2.5 Geology, Seismology, and Geotechnical Engineering

In Section 2.5, “Geology, Seismology and Geotechnical Engineering,” of the site safety evaluation report (SSAR), the applicant, System Energy Resources, Inc. (SERI), provided a detailed description of the geological, seismological, and geotechnical engineering properties of the early site permit (ESP) site. In this safety evaluation report (SER), Section 2.5.1, “Regional Geology,” describes basic geological and seismological data, especially the data published since 1986 for the area within a 200-mile radius of the ESP site, and presents updated seismic sources. Section 2.5.2, “Vibratory Ground Motion,” evaluates the vibratory ground motion for the ESP site and analyzes the safe-shutdown earthquake (SSE) ground motion. Section 2.5.3, “Surface Faulting,” describes the potential for surface faulting at or near the surface of the ESP site. Section 2.5.4, “Stability of Subsurface Materials and Foundations,” presents the results of site geotechnical investigations and discusses the stability of subsurface materials and foundations. Section 2.5.5, “Stability of Slopes,” defers the analyses for slope stability at the site and dam perf

(Figures 2.5.4-5 through 2.5.4-14) (Updated final version of SSAR Figures 2.5-87 and 2.5-96)

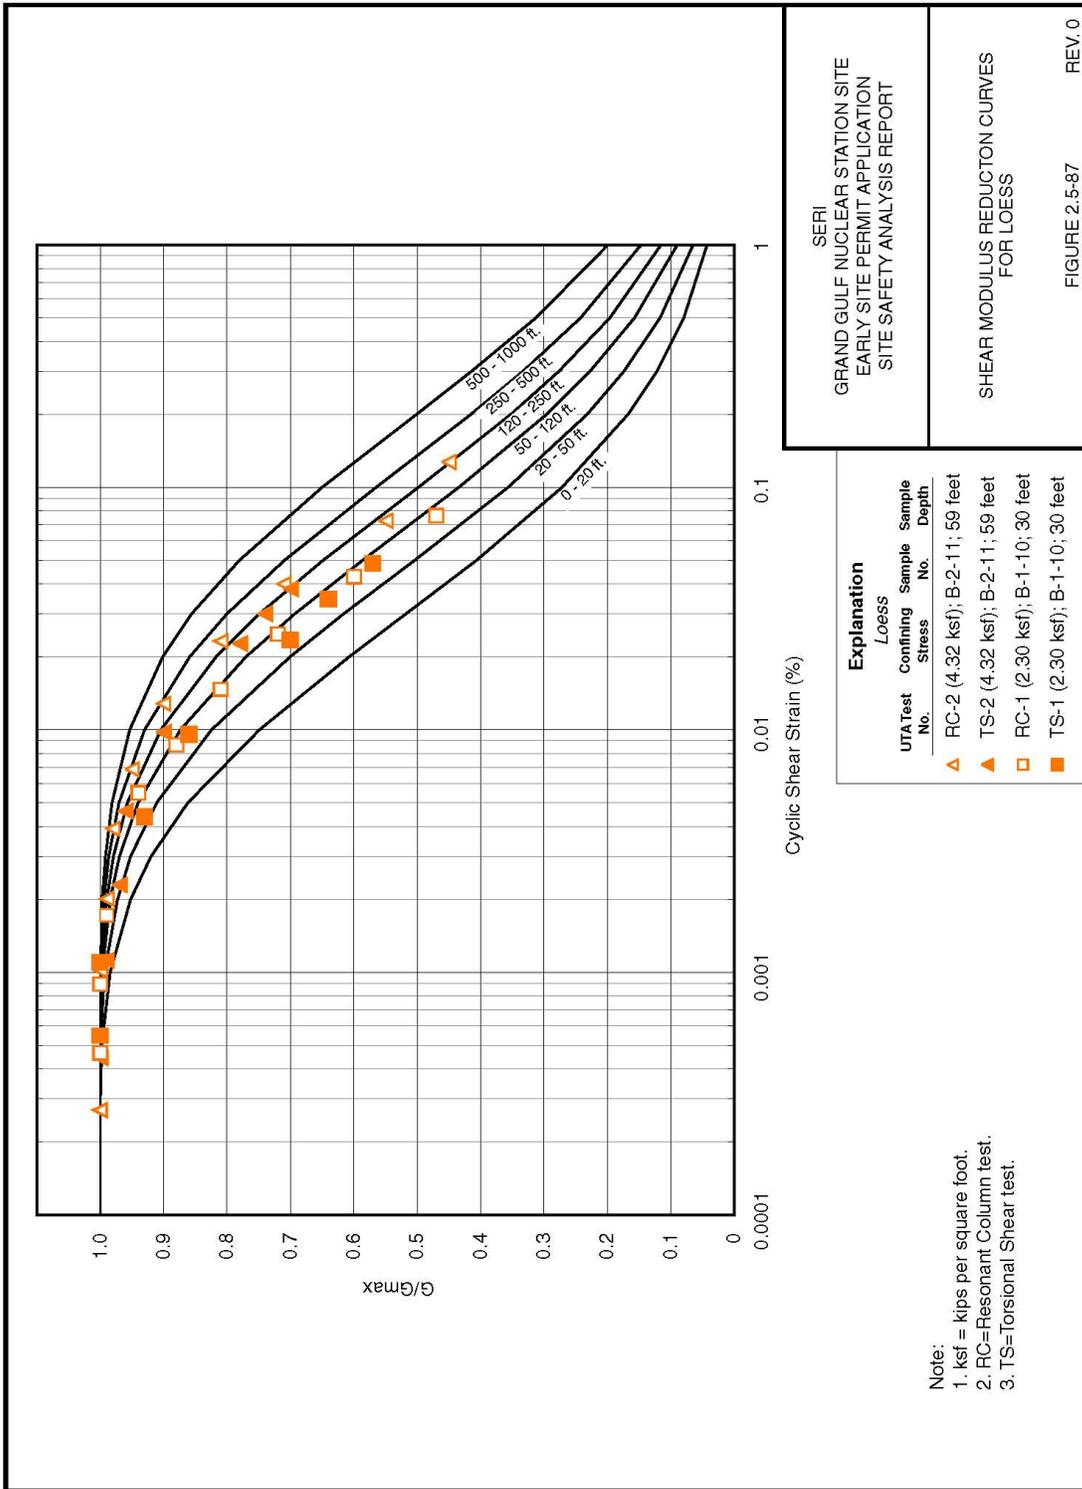
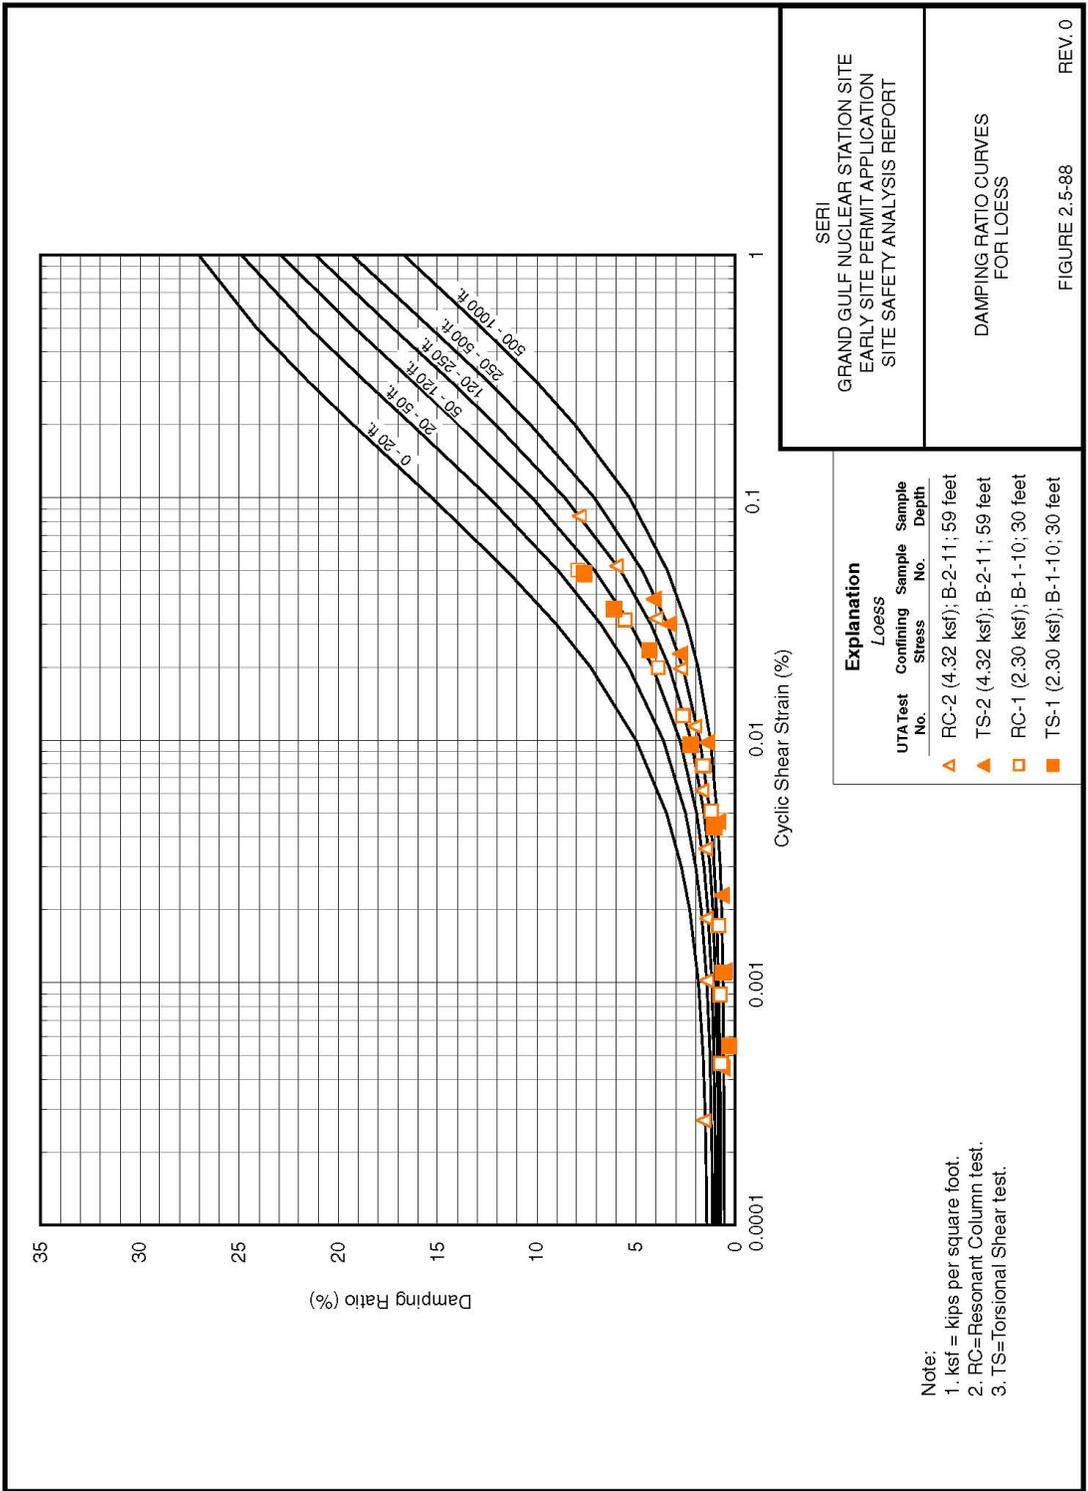
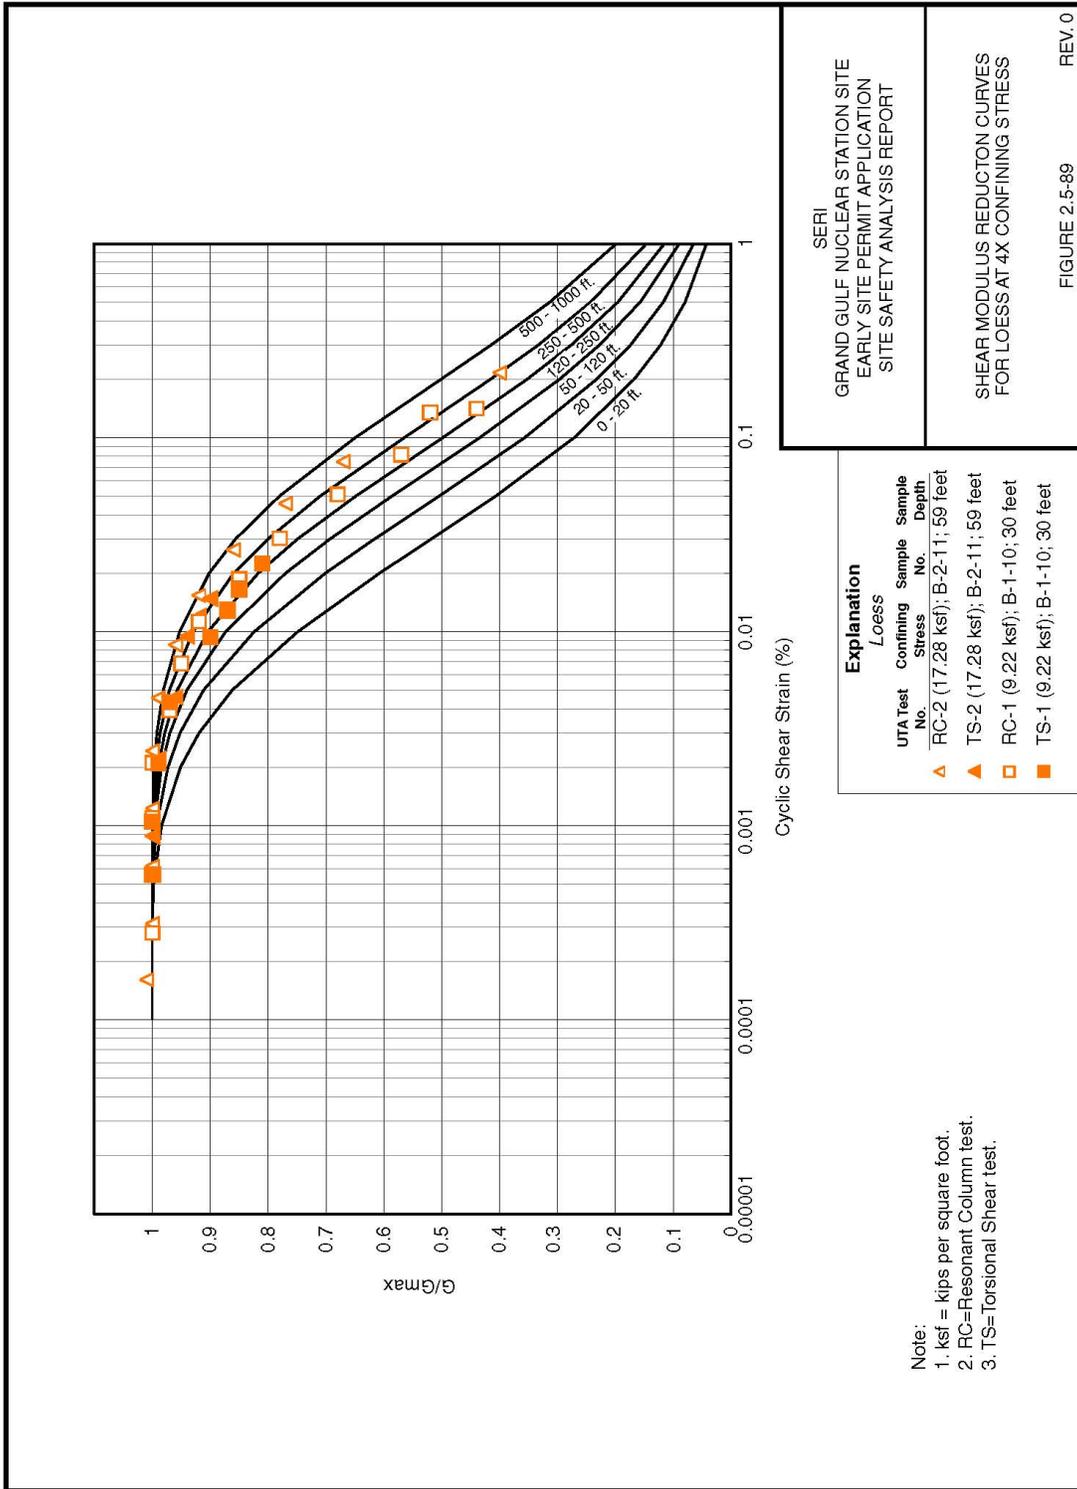
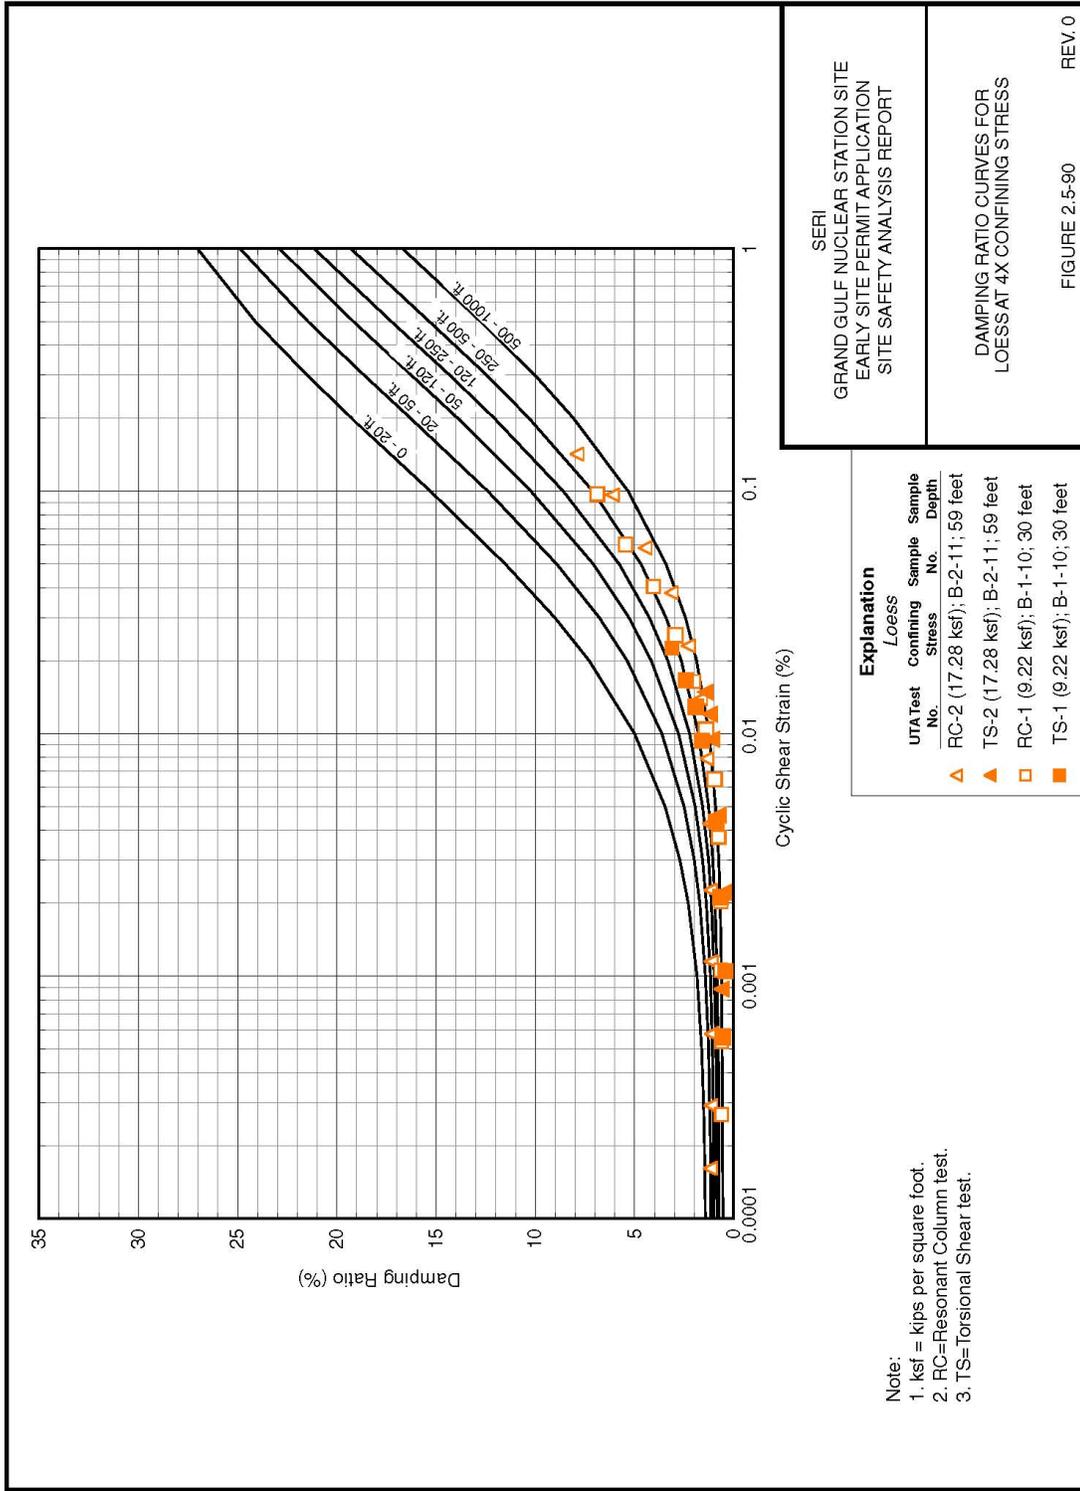
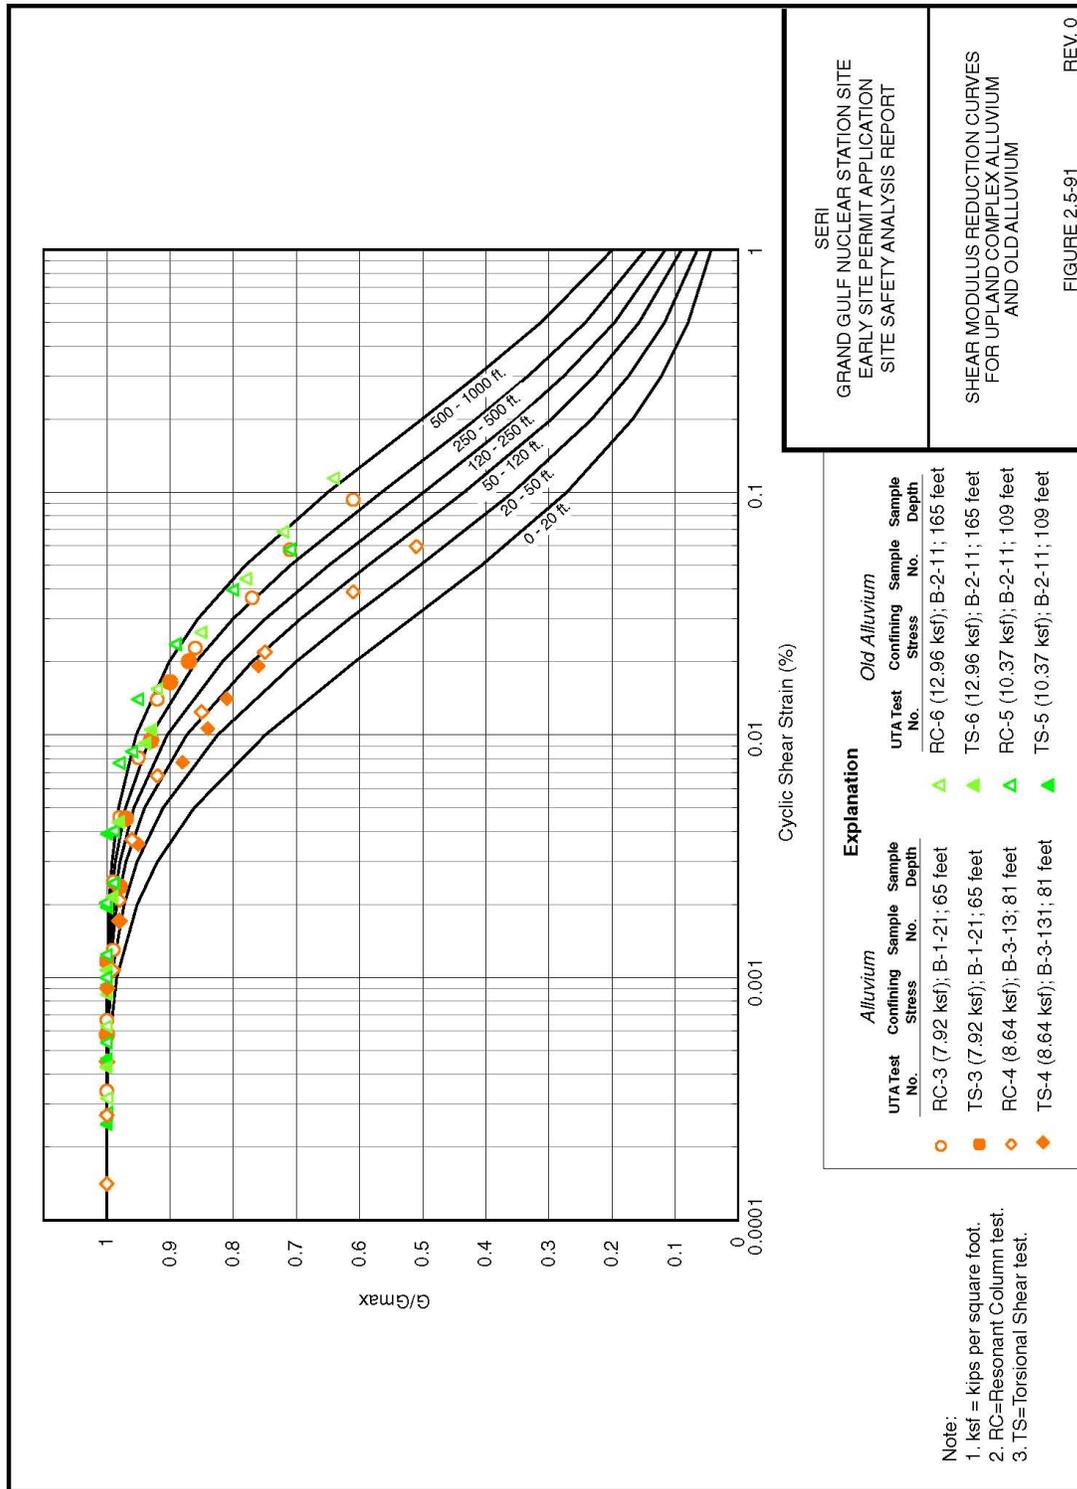
In RAI 2.5.4-7, the staff asked the applicant to provide its rationale for not incorporating these effects in the site response calculations and to evaluate the potential impact of these modifications on the computed surface UHS. In its response, the applicant referred to its response to RAI 2.5.4-6 and stated that the analysis and selection of the appropriate EPRI-TR curves for shear modulus reduction and hysteretic damping fully account for the effects of possible disturbance to the test specimens resulting from stress release during sampling, as well as possible movements during testing. The applicant considered the effects of sample relaxation by examining the results from testing soils at both the estimated in situ confining stress and 4 times the estimated in situ confining stress. The applicant plotted these two data sets together on the EPRI-TR base curves as shown in Figures 2.5.4-5 through 2.5.4-12, which replicate SSAR Figures 2.5.4-87 to 2.5-94 and Figures 2.5.4-13 and 2.5.4-14. The two data sets were weighted to select the most representative EPRI-TR curve.

In its response, the applicant further stated that the shear modulus reduction and damping curves adopted for use in the site response analysis represent the best fit to the dynamic soil test results that account for the effects of soil disturbance and overconsolidation. The applicant also considered the uncertainty and variability in these values in the site response modeling by developing randomizing curves about the selected base case EPRI-TR curves using an assumed lognormal distribution. The applicant further discussed the randomization process in its response to RAI 2.5.4-8 (for shear wave velocity input). The applicant considered that the EPR-TR curves selected for the base case for site response analysis are appropriate for the site soil conditions and account for both sample disturbance and overconsolidation. Therefore, incorporation of these issues would not impact the computed surface UHS.
